MIAMI BEACH

Staff Report & Recommendation

Design Review Board

SUBJECT: **DRB20-0505**
666 71st Street, 6973 Indian Creek Drive, and 6980-6994 Carlyle Avenue

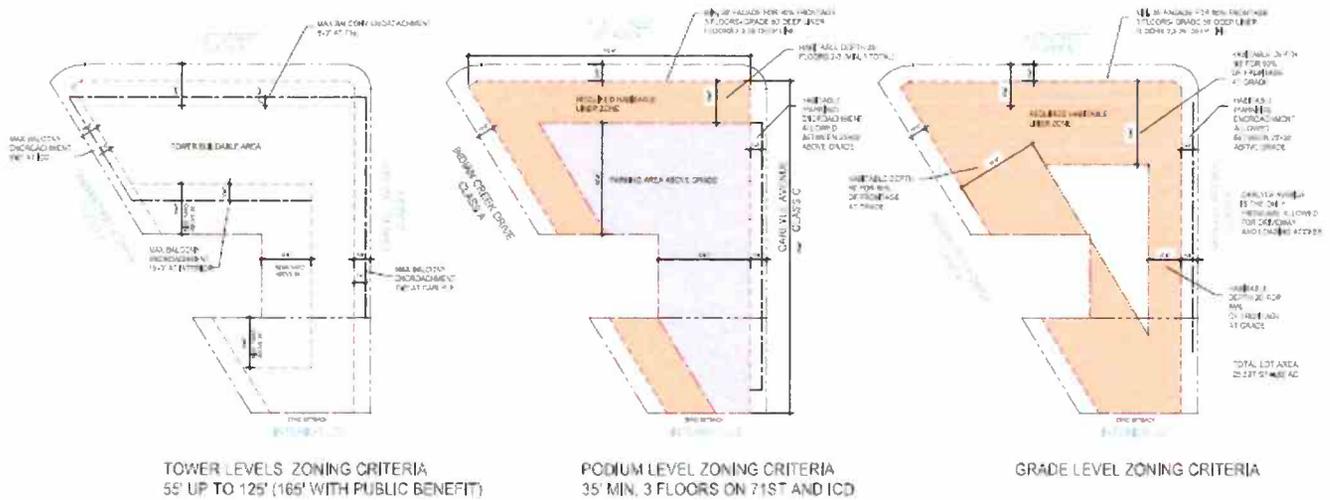
The subject property is the westernmost block at the edge of the TC-C district, consisting of six out of eight historically platted parcels of a triangular block that comprise Block 15. The project site is located at 666 71st Street, at the intersection of Indian Creek Drive and 71st Street, with Carlyle Avenue as the eastern boundary and an interior lot line to the south. A midblock parcel along Indian Creek Drive and the southernmost parcel of the block are not part of this application. This 0.58-acre triangular block sits at the convergence of two primary corridors within the City: Indian Creek Drive and 71st Street, which are both Class A streets. This intersection has significant traffic back up and congestion.

As illustrated above, it is extremely challenging, if not impossible, to address all of the habitable liner requirements of Class A street frontages with regard to height, depth and levels, as well as design a functional parking system on a triangular lot. The TCC requires screening parking and providing habitable active uses at a height and intensity commensurate with the corridor they are adjacent to. Due to the triangular shape and dimensions of the site assemblage, it appears that it is not geometrically possible to provide the parking sought by the applicant (but not all required), while meeting the dimension and spatial requirements for the parking stalls, drive aisle widths, turn radiuses and back up dimensions necessary to design a safe parking system and comport with the Class A street requirements pertaining to the liner uses. Staff would note that the required habitable space with a depth of 50'-0" is provided along the 71st Street ground floor, as well as portions of the ground level along Indian Creek Drive, which is essential to the pedestrian experience.

In this proposal, the design substitutes the habitable liner used to screen the parking by providing architecturally relevant and contextually appropriate façade screening systems and providing residential units on 71st Street and partially on Indian Creek Drive and Carlyle Avenue on levels four to twelve. Staff has worked closely with the applicant in prioritizing the street level activation of Indian Creek Drive and 71st Street as the significant retail opportunities for this signature gateway site. The design endeavors to meet the intent of the code to activate the street and provide visual screening of the parking through the use of enhanced architectural screening. Staff does suggest continuing refinement of the parking screening, as the design is of paramount importance at this gateway site and considering the screening will be at a much lower elevation than typical and thus more visible and subject to more severe scrutiny from pedestrians and motorists. As such, staff recommends approval of variances #1-8 associated with the habitable depth at the second and third levels along both Class A streets.

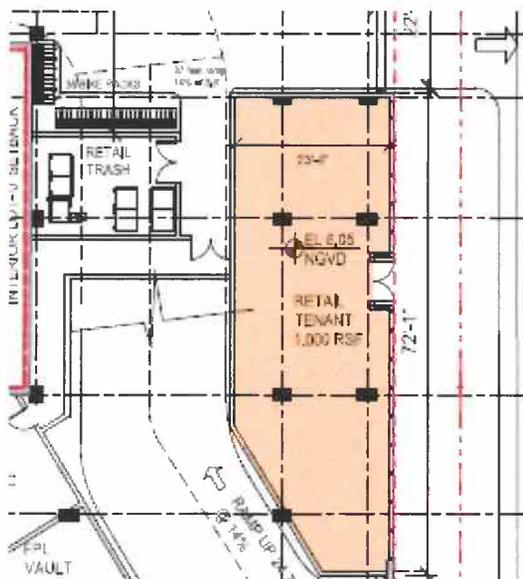
The ground floor retail space must contain habitable space along 85% of the building façade with a minimum depth of 20'-0" for Class C frontages. Based on the length of the property facing Carlyle Avenue, a linear requirement of 131'-4" of habitable space is required with 20'-0" of habitable depth. The design provides 140'-0" of liner along this street. The project contains approximately 198'-0" of linear frontage with the two driveways subtracted brings the amount to 154'-0" for zoning calculation purposes. However, the depth of 20'-0" is not consistent for the entire length. Approximately 22'-0" of frontage adjacent to the driveway does not provide the required 20'-0" in depth, as the driveway turns into its approach of the ramp. Staff finds that there are practical difficulties inherent to the irregular shape of the property that result in the variance requested. In reviewing the ground floor site plan comprehensively, the 71st Street frontage contains a continuous and uninterrupted commercial space for the entirety of the 165'-2" of Class A frontage and comports with the transparency requirement for visual display into the space. Working closely with staff through multiple meetings, it was agreed upon that the priority of compliance with the TC-C stringent street frontage regulations would be the two Class A streets. However, the applicant did make a concerted effort to activate and design Carlyle as closely as possible to the ground floor regulations.

Detail of site plan loading bay area accessed off of Carlyle Avenue

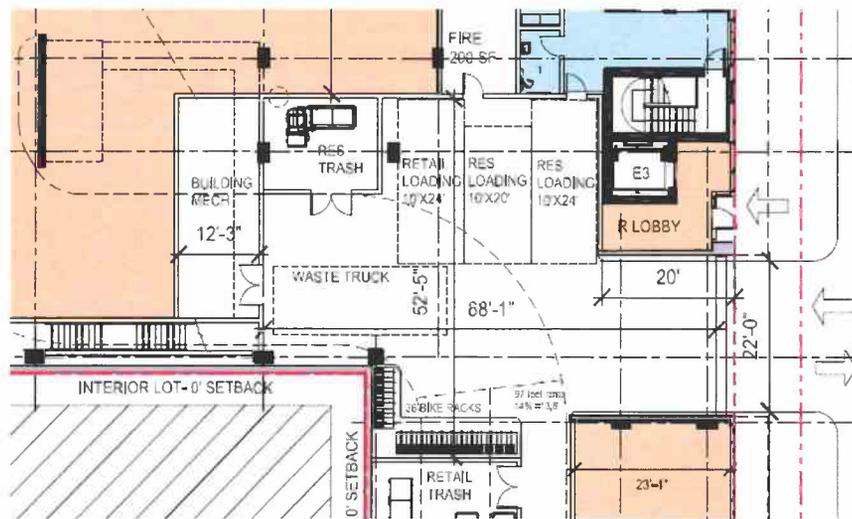
15. A variance to allow loading area / surface parking to be not entirely screened from public right of ways and pedestrian path along Carlyle Avenue (Class C).

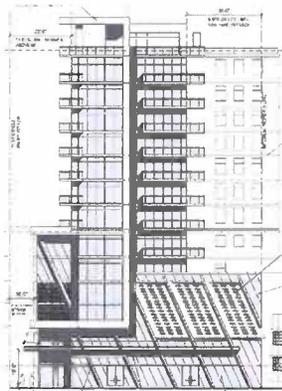
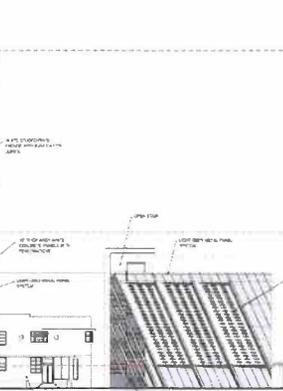
- e. *DRB recommended simplifying architectural language. The removal of the angular design elements, simplification of the precast panel screen perforations, and the revisions to the southern portion of the Indian Creek Drive podium have all worked together for a more generally clean façade design. (See revised elevations and renderings along 71st Street)*

Increased the storefront glazing height
 Straightened the vertical accent fins and added texture with Juliette balconies

While the revised precast concrete panels have been simplified and still reflect the overall screening materials, the exit stair has been modified to create a separation reveal between the existing building and the podium, and the ground floor façade has been revised to include a relief pattern and green screen for a living wall on the south. (See revised elevations and renderings along Indian Creek Drive)

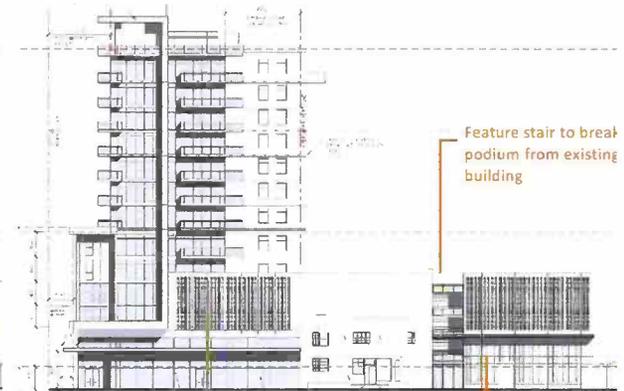
- f. DRB recommended addressing the southern podium façade on Indian Creek Drive separately. The removal of the angular design elements, simplification of the precast panel screen perforations, and the revisions to the southern portion of the Indian Creek Drive podium have all worked together for a more generally clean façade design. (See revised elevations and renderings along 71st Street)

Straightened the architectural precast panels

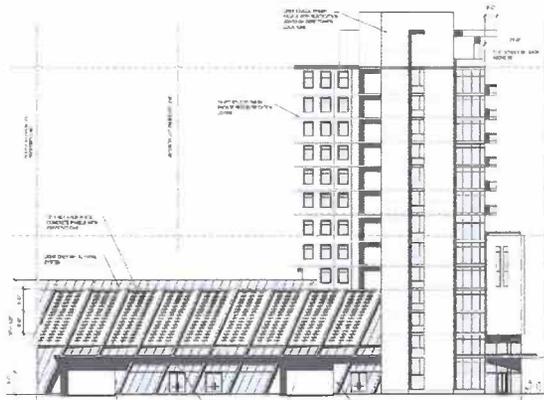
Straightened the architectural precast panels- simplify design

Living wall lattice at utility areas, separate southern facade

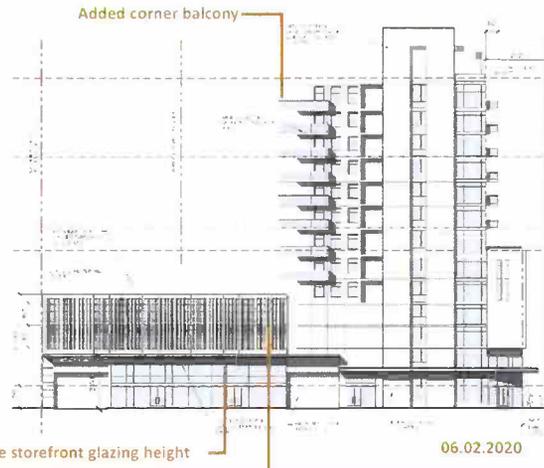
Added corner balcony
